## Oyster Point Marina West Basin Access Improvements (Contract 2024-04)

### ADDENDUM NO. 1 RESPONSE TO QUESTIONS

FROM: San Mateo County Harbor District

**1** 16 INCH DIA STEEL PIPE PILE ELEVATION  
SCALE: 1" = 1'-0"

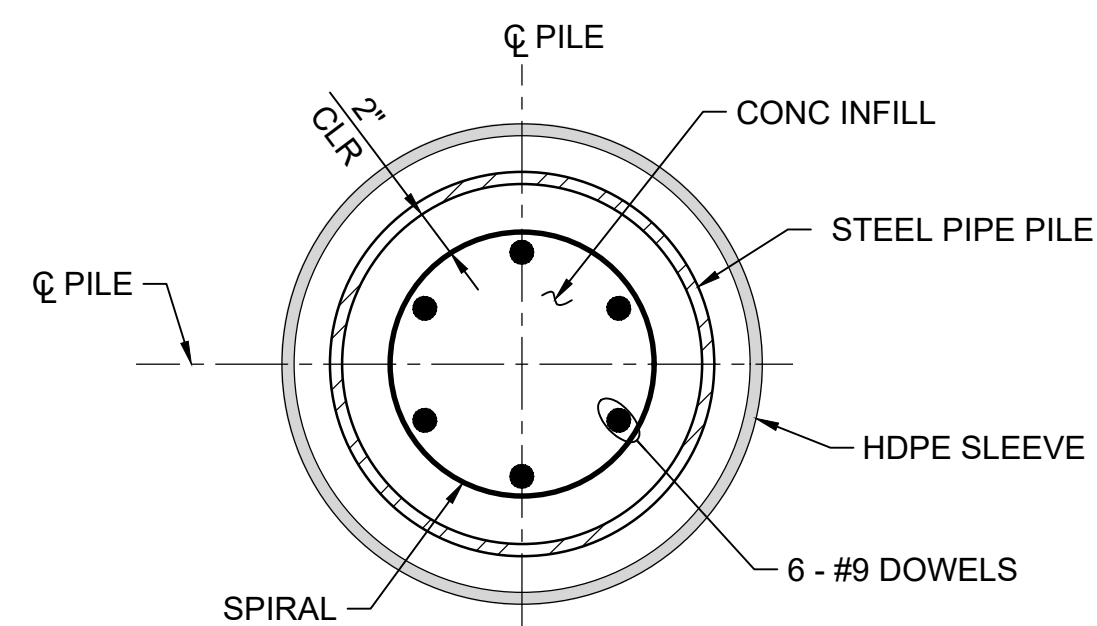
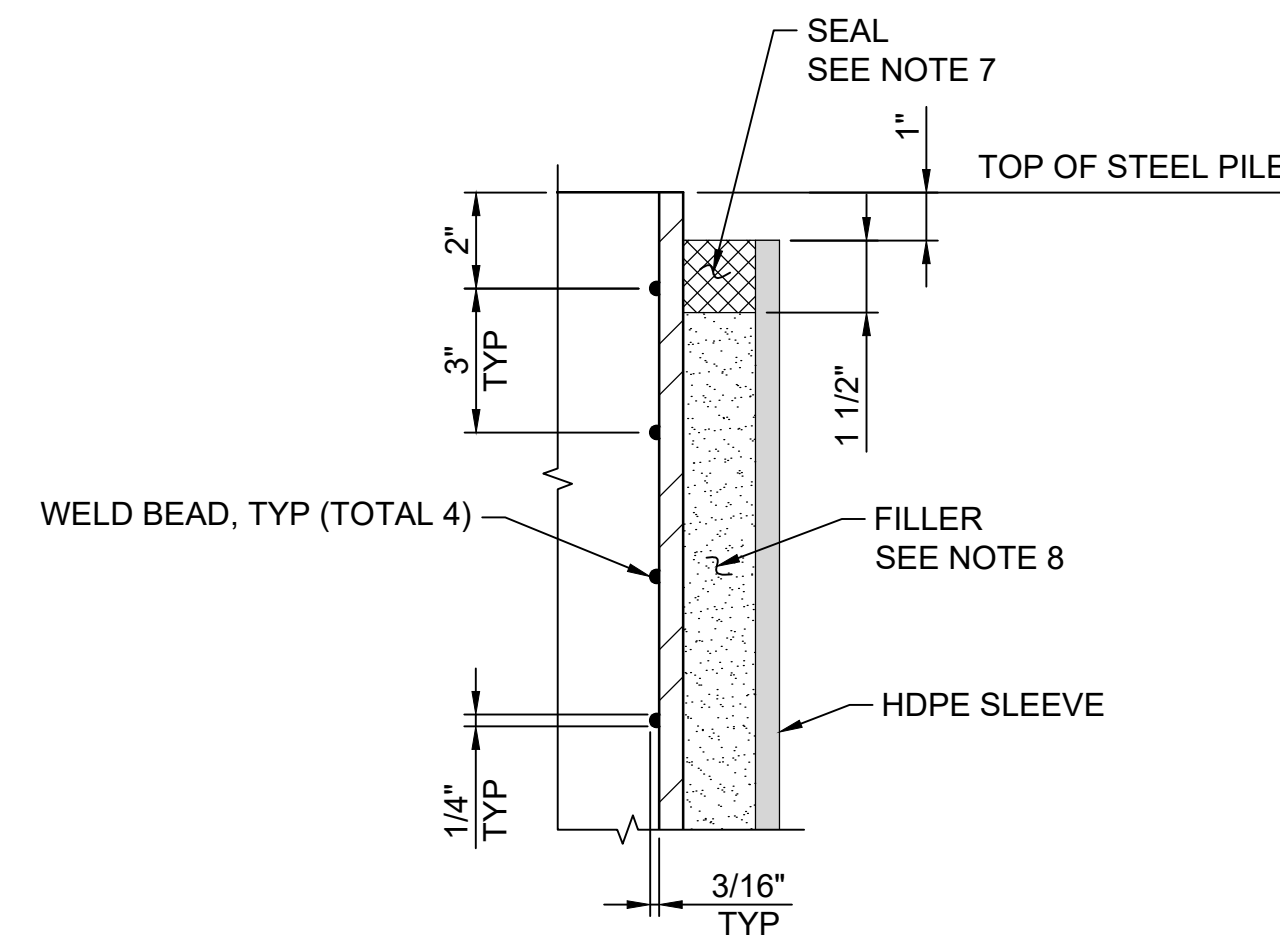
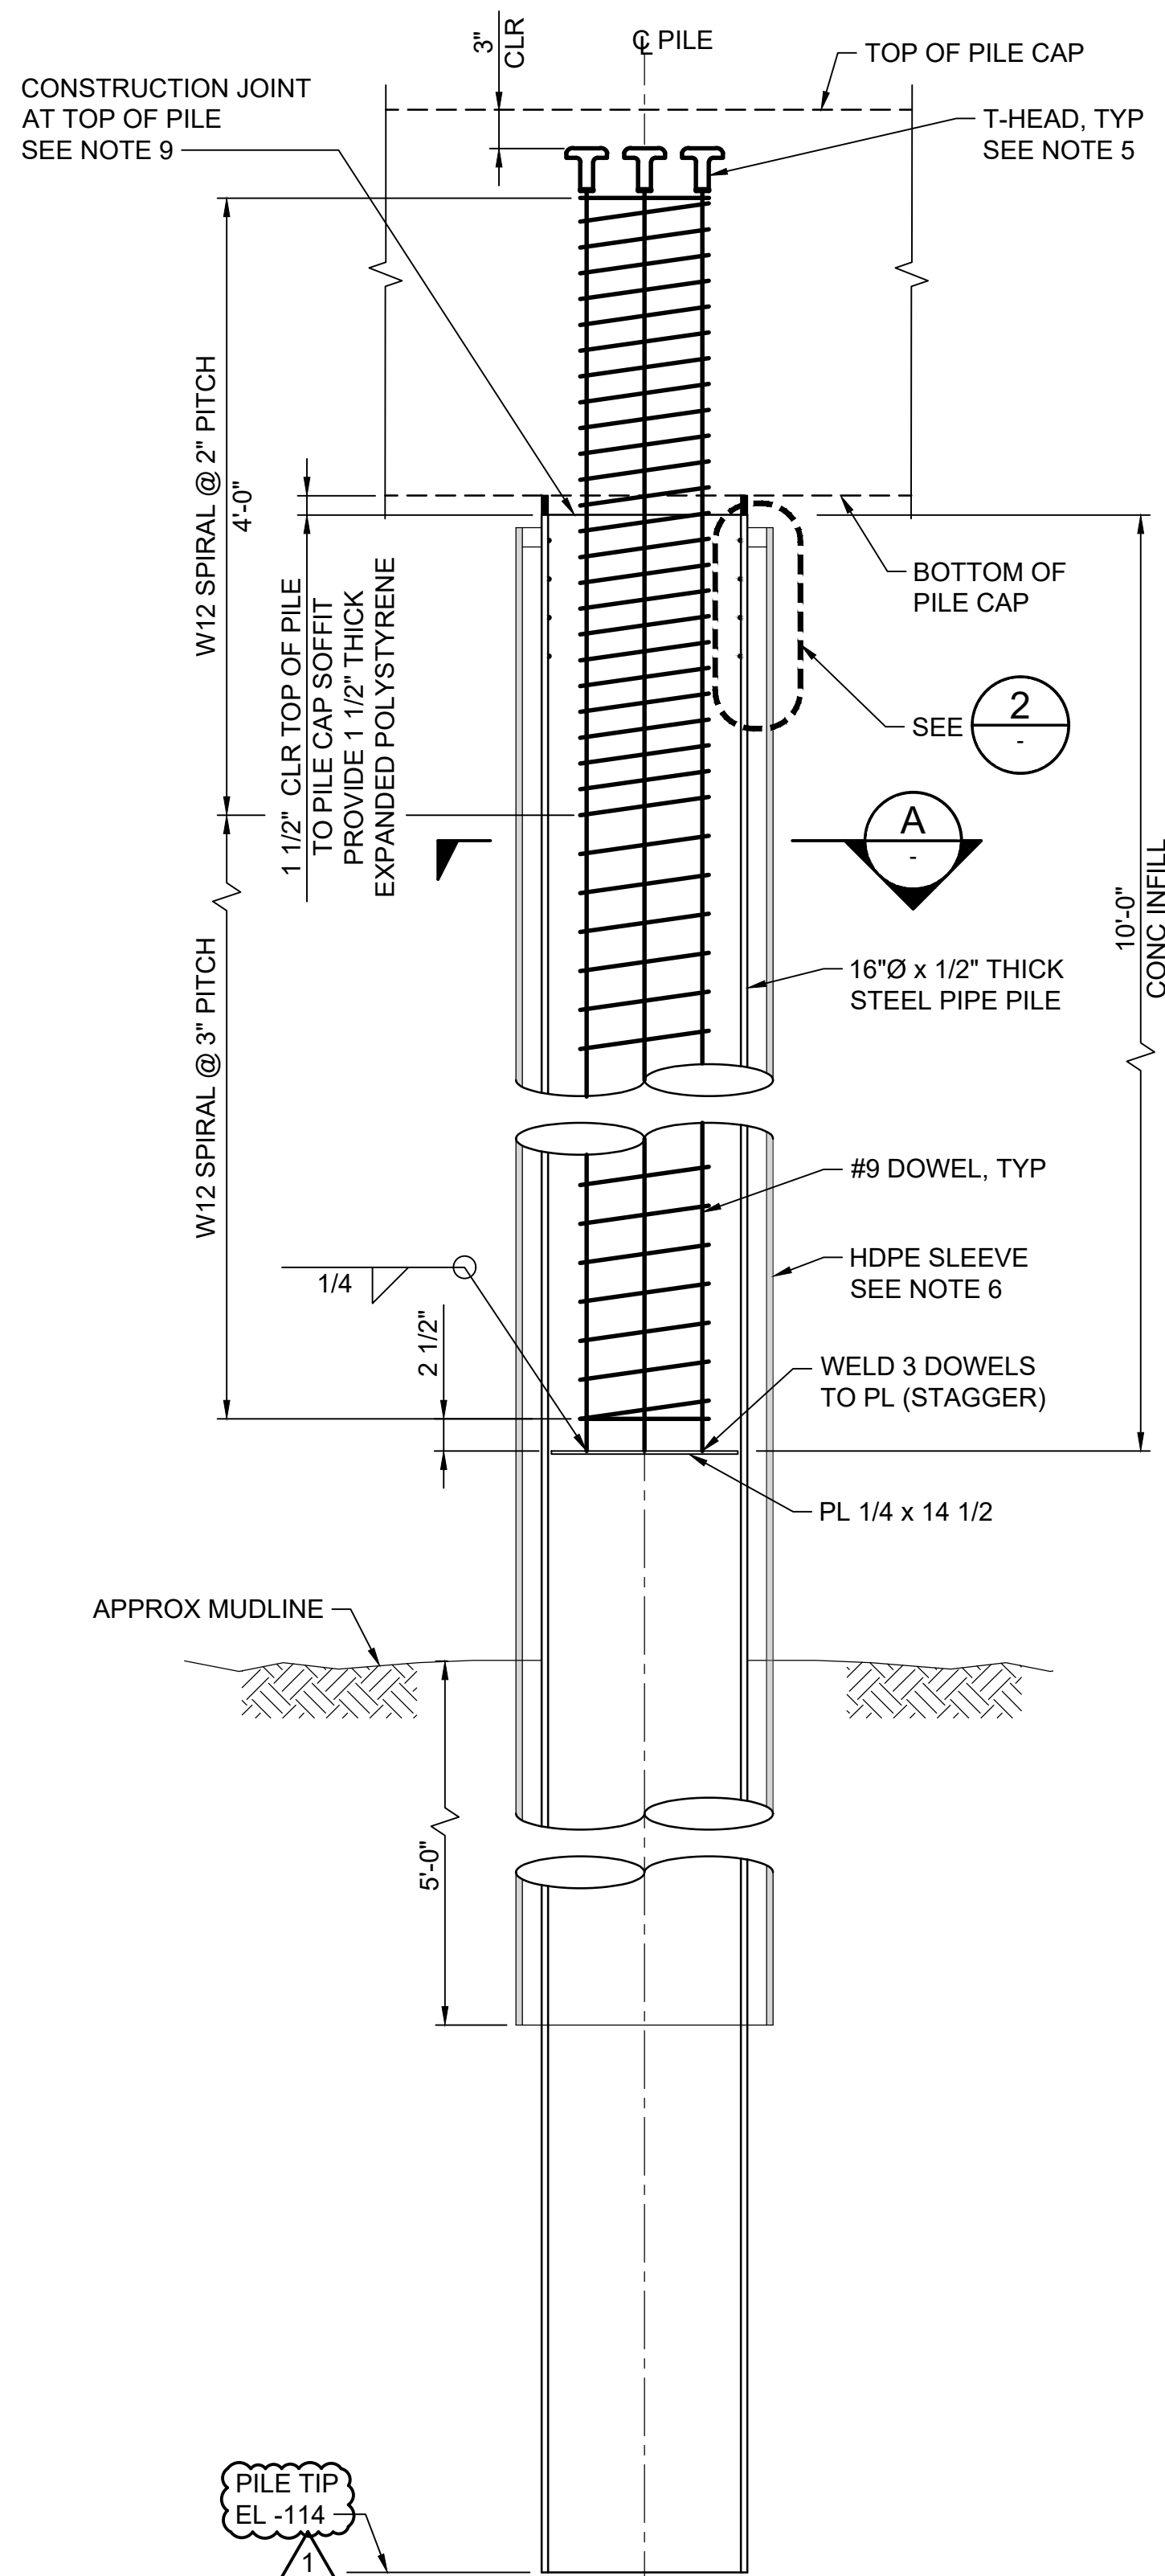
Question 16: Please provide a pile length schedule to confirm exact pile lengths at each location, to ensure bidders price the same quantities.

1. Detail 1 “16 INCH DIA STEEL PIPE PILE ELEVATION”:

a. Revise callout from “PILE TIP EL -115” to “PILE TIP EL -114”

District response: Piles are 125' long. The pile tip elevation has been raised from -115' to -114'.
